Our Reference: 64076/PSN2

Re: P/2019/34799 - Highways England Post Submission Note 2

1. M6 Junction 20 Mitigation Model

Appendix A – Grappenhall Lane/A50 and M6 Junction 20 Mitigation Scheme

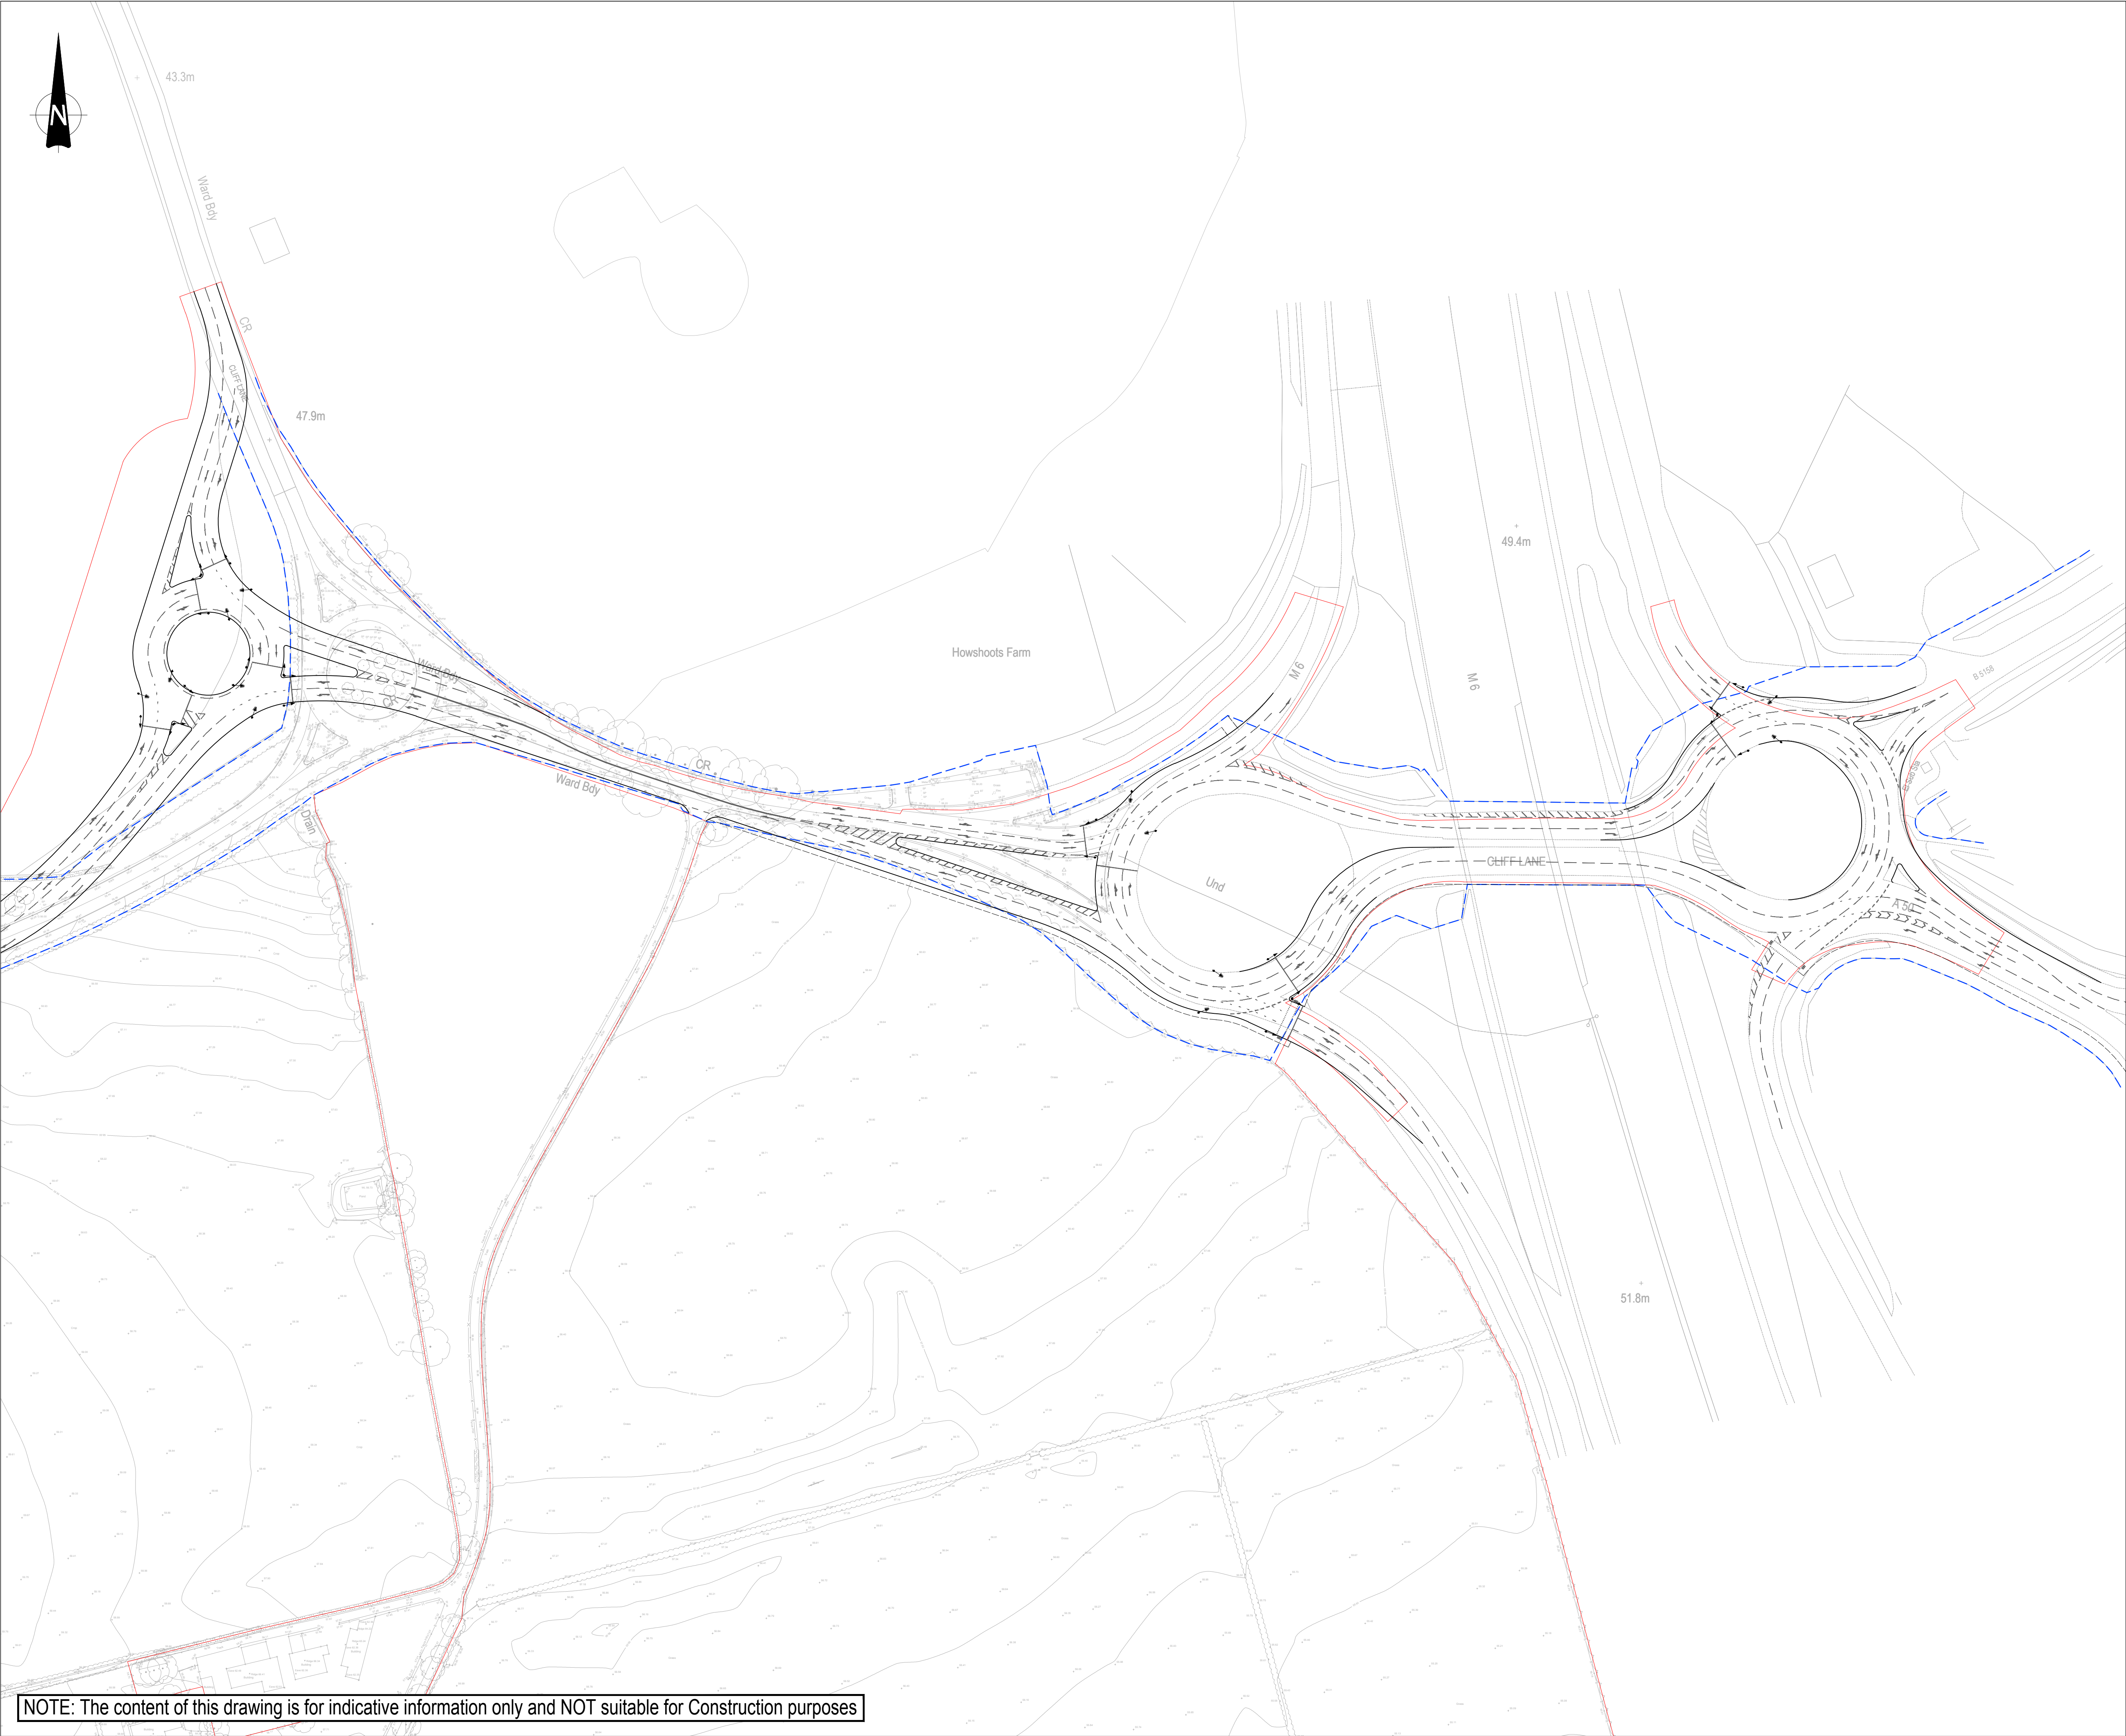
Arm J1:1 is modelled with both the nearside and offside lanes accommodating the movement to the downstream middle of three lanes. The drawing shows only the offside feeding the downstream middle lane.

Arm J1:3 there appear to be significant differences in the maximum flow whilst giving-way values used between the base and proposed models without obvious justification.

Arm J1:4 has a weave from the offside lane to the downstream middle and nearside lanes. This reflects the base but is not needed to accommodate the movement from M6-M6 due to the provision of a connector from the middle to downstream middle and nearside lanes and should be removed. The lane markings on this part of the network should also be reviewed.

Arm J1:9 is modelled with both the nearside and middle lanes feeding the nearside immediately downstream and the offside lane feeding the middle and offside downstream lanes. The drawing shows a continuation of all three lanes

Arm J1:10 the model shows the middle lane feeding the nearside and middle lanes of the downstream circulatory whereas the drawing shows this lane feeding the offside exit lane and nearside downstream circulatory lane

Arm J2:1 is not marked to allow the movement from offside to both downstream lanes on the circulatory although the model allows this.

Arm J2:2 is modelled and drawn with the offside lane being right only but the design allows for it to also be left.

Arm J2:3 is drawn with a left only and right only but the nearside is actually left and right.

In addition, Given the nature of traffic flows on a roundabout, all lanes should be coded as being 'nearside' unless there is strong justification not to do so.

The model has been amended.

The maximum flow for J1:3 has been increased to take account of the proposed improvements to this roundabout as shown in Drawing 64076-7501-P06. The ARCADY model for the proposed improvements is attached.

Drawing 64076-7501-P04 and the model have both been amended. The amended drawing (ref: 64076-7501-P06 is provided at the rear of this note.

The model has been amended.

The model has been amended.

The model and the lane markings (see Drawing 64076-7501-P06) has been amended.

The model and lane markings (see Drawing 64076-7501-P06) has been amended.

The model and lane markings (see Drawing 64076-7501-P06) been amended.

The model and drawing of the proposed mitigation has been updated on the above basis and the drawing is included as Appendix A. The raw model will be forwarded by email separate to this note.
